REPLAT OF PART OF KINKAID PARK

RE: SUB 2003-71 - One-Step Final Replat of Kinkaid Park Addition

At the regular meeting of the Subdivision Committee of the Metropolitan Area Planning Commission on Thursday, July 17, 2003, the above captioned plat was considered. The action of the Committee was to approve the one-step final plat, subject to the following staff comments:

CASE NUMBER: SUB 2003-71 -- REPLAT OF KINKAID PARK ADDITION

"Replat of KINKAID PARK"
FINAL PLAT SHEET 1 OF 1

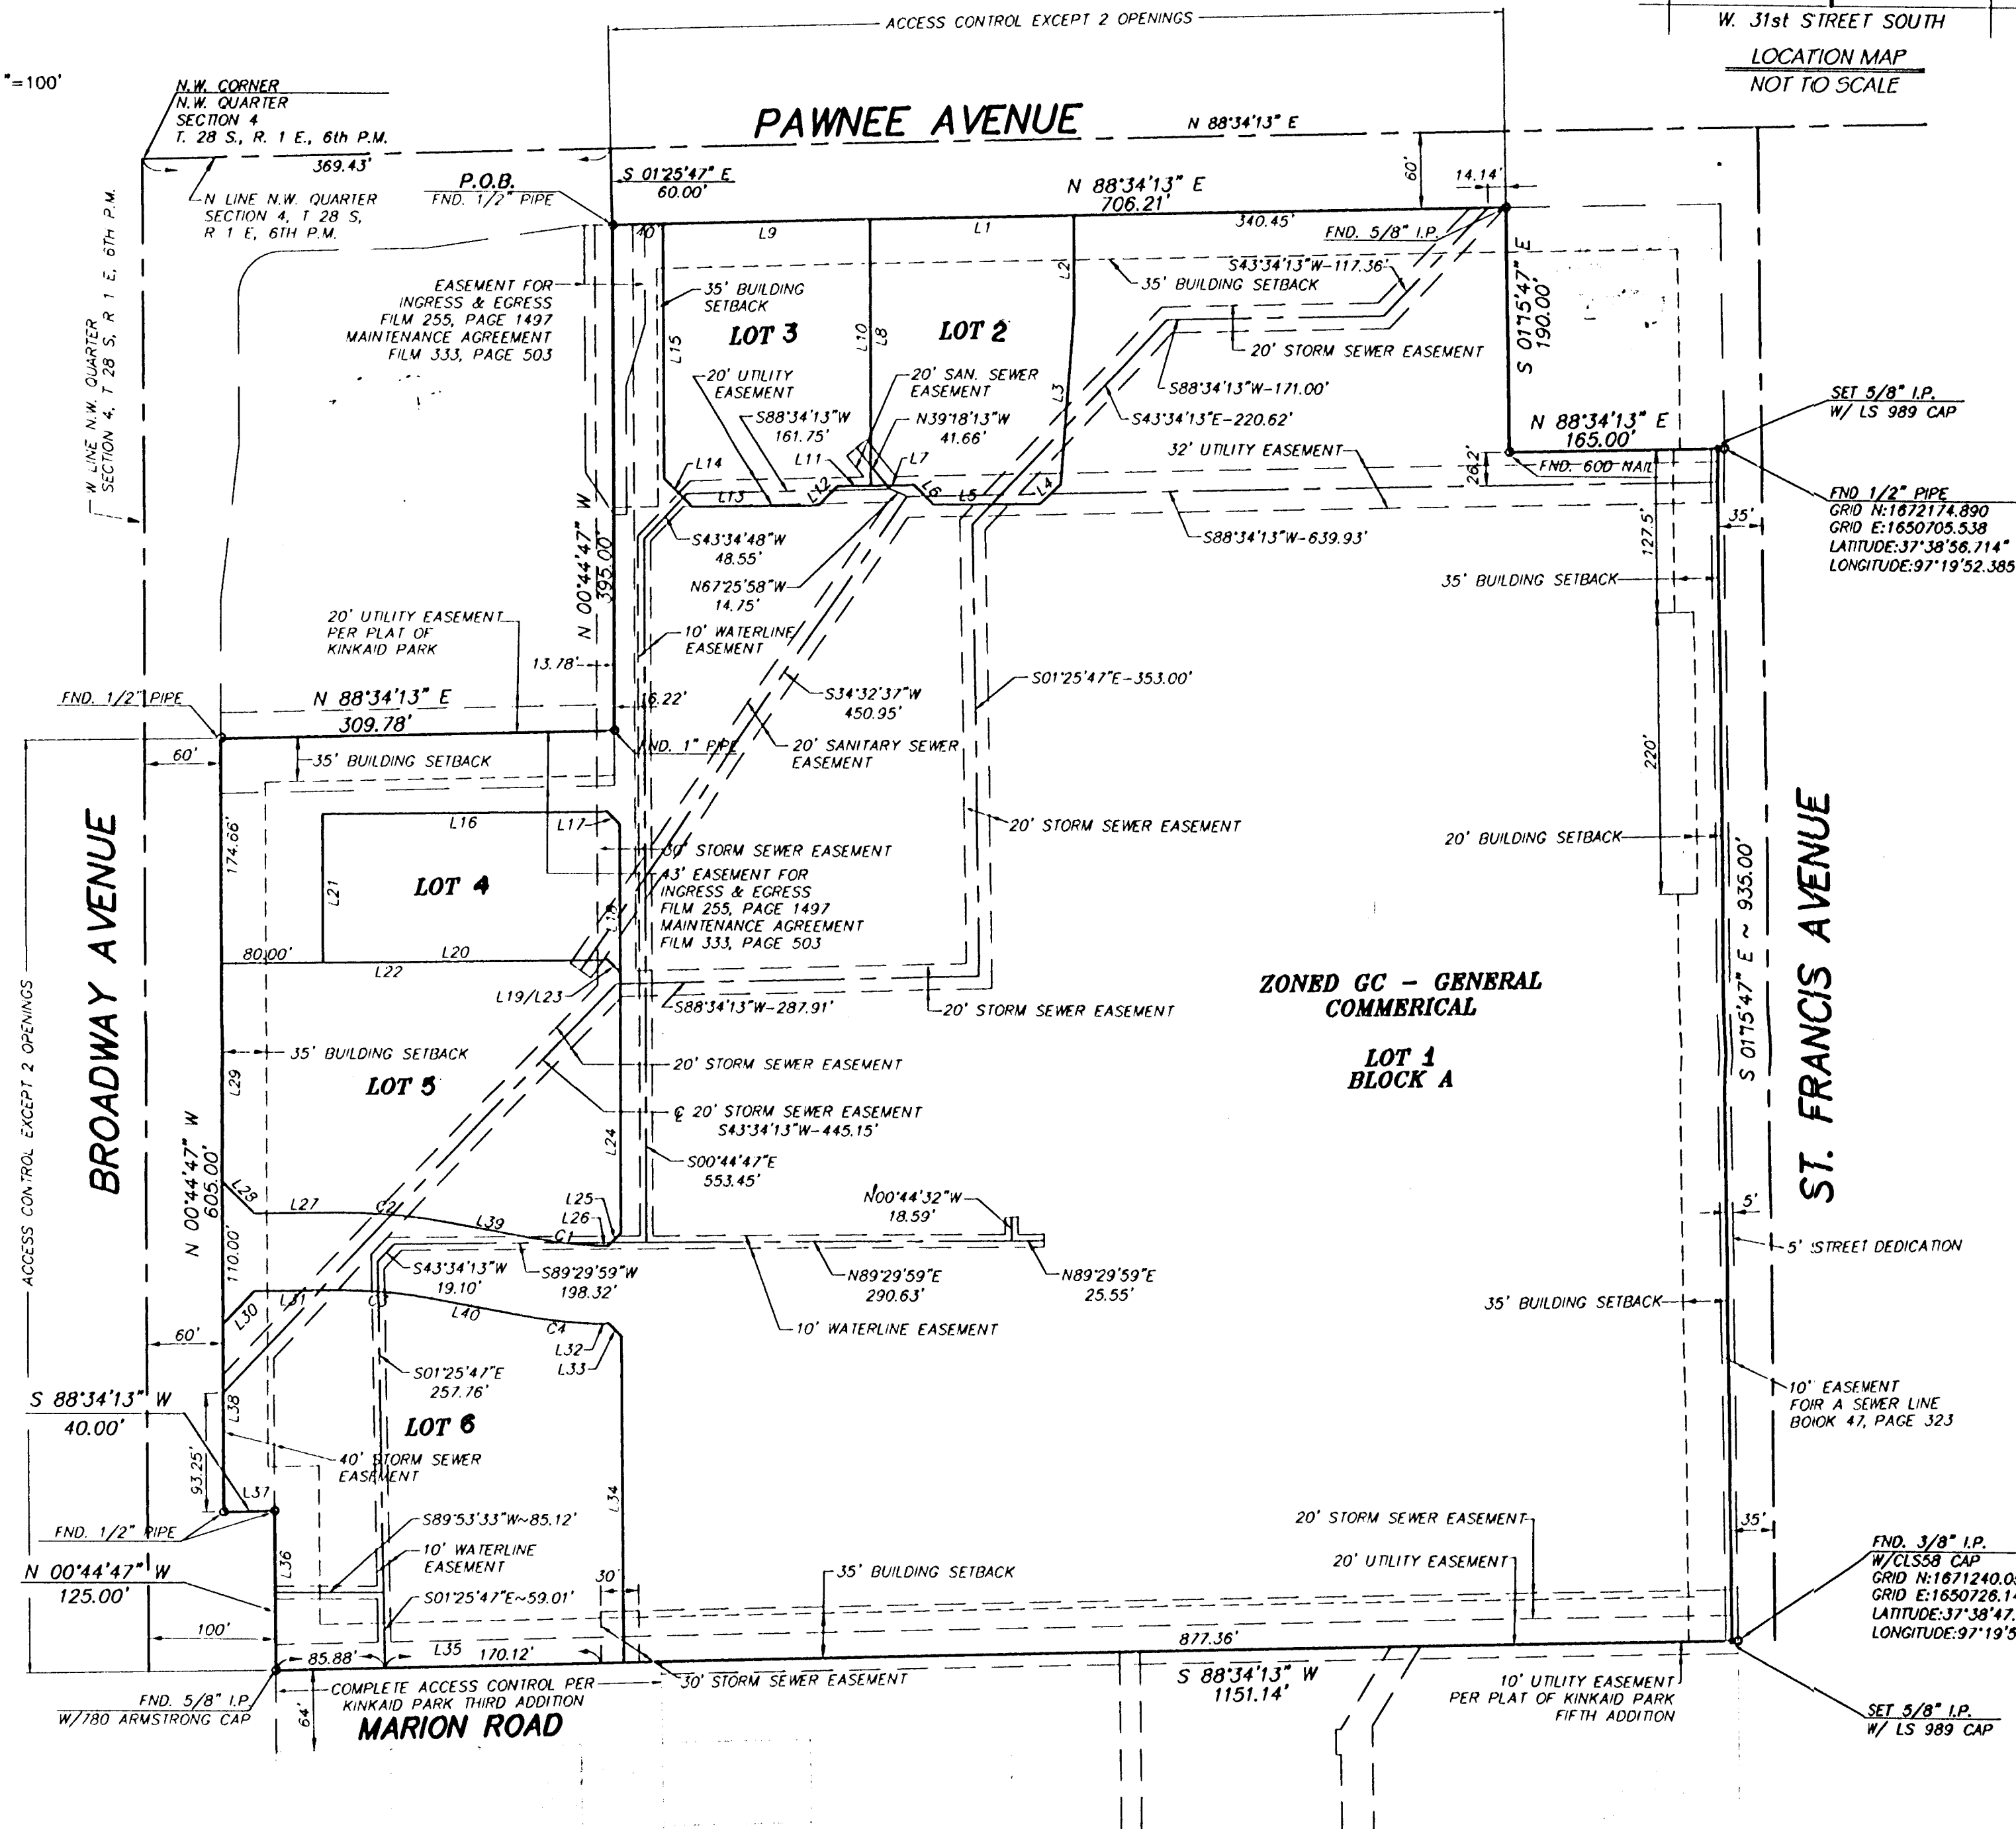
- A. City water services are available to serve the site. The applicant shall guarantee the extension of sanitary sewer to serve the lots being platted. Utility easements for water services need to be platted.

- C. A guarantee for the sewer abandonment will be required.
- D. The 10-ft sewer easement needs to be increased to 20 feet and extended to serve Lot 2C.

- J. County Surveying has requested a central angle (delta) with curve data.
-  K. The 20' portion of building setback along the east side of Lot 2A needs to be located.

- N. County Surveying has requested a bearing on internal lot lines.
- O. County Surveying has advised that the storm sewer easement along the south line of Lot 2A needs to be located. (20' north of south line)

- P. County Surveying has advised that the 10' sanitary sewer easement running southwest-northeast needs to be located.
- Q. County Surveying has advised that interior bearings need basis shown since some are plat and some are SPCS.

- R. The lot lines need to be solid lines.
- S. In accordance with the CUP amendment, a cross-lot circulation agreement is needed to assure internal vehicular movement between the lots.

- T. Traffic Engineering has requested additional right-of-way along St. Francis. The Subdivision Regulations require a 35-ft half-street right-of-way for a commercial street.

- U. The lots shall be renumbered as 1 through 6, Block A.
- V. A note shall be placed on the final plat, indicating that this Addition is subject to the conditions of to the Kinkaid Park Commercial CUP (CUP 2003-19, DP-43 Amendment #3).

- DD. Marion Rd. which abuts the plat to the south, shall be designated on the plat along with its right-of-way width.
- EE. The Applicant is reminded that a platting binder is required with the final plat. Approval of this plat will be subject to submittal of this binder and any relevant conditions found by such a review.

- A. City water services are available to serve the site. The applicant shall guarantee the extension of sanitary sewer to serve the lots being platted. **Utility easements for water services need to be platted.**

- C. A guarantee for the sewer abandonment will be required.
- D. **The 10-ft sewer easement needs to be increased to 20 feet and extended to serve Lot 2C.**

- J. **County Surveying** has requested a central angle (delta) with curve data.
- K. The 20' portion of building setback along the east side of Lot 2A needs to be located.

- N. **County Surveying** has requested a bearing on internal lot lines.

- O. County Surveying has advised that the storm sewer easement along the south line of Lot 2A needs to be located. (20' north of south line)
- P. County Surveying has advised that the 10' sanitary sewer easement running southwest-northeast needs to be located.

- Q. County Surveying has advised that interior bearings need basis shown since some are plat and some are SPCS.
- R. The lot lines need to be solid lines.

- S. In accordance with the CUP amendment, a cross-lot circulation agreement is needed to assure internal vehicular movement between the lots.
- T. Traffic Engineering has requested additional right-of-way along St. Francis. The Subdivision Regulations require a 35-ft half-street right-of-way for a commercial street.

- U. The lots shall be renumbered as 1 through 6, Block A.
- V. A note shall be placed on the final plat, indicating that this Addition is subject to the conditions of to the Kinkaid Park Commercial CUP (CUP 2003-19, DP-43 Amendment #3).

- CC. The MAPC signature block needs to reference "Bernard A. Hentzen, Chair".
- DD. Marion Rd. which abuts the plat to the south, shall be designated on the plat along with its right-of-way width.
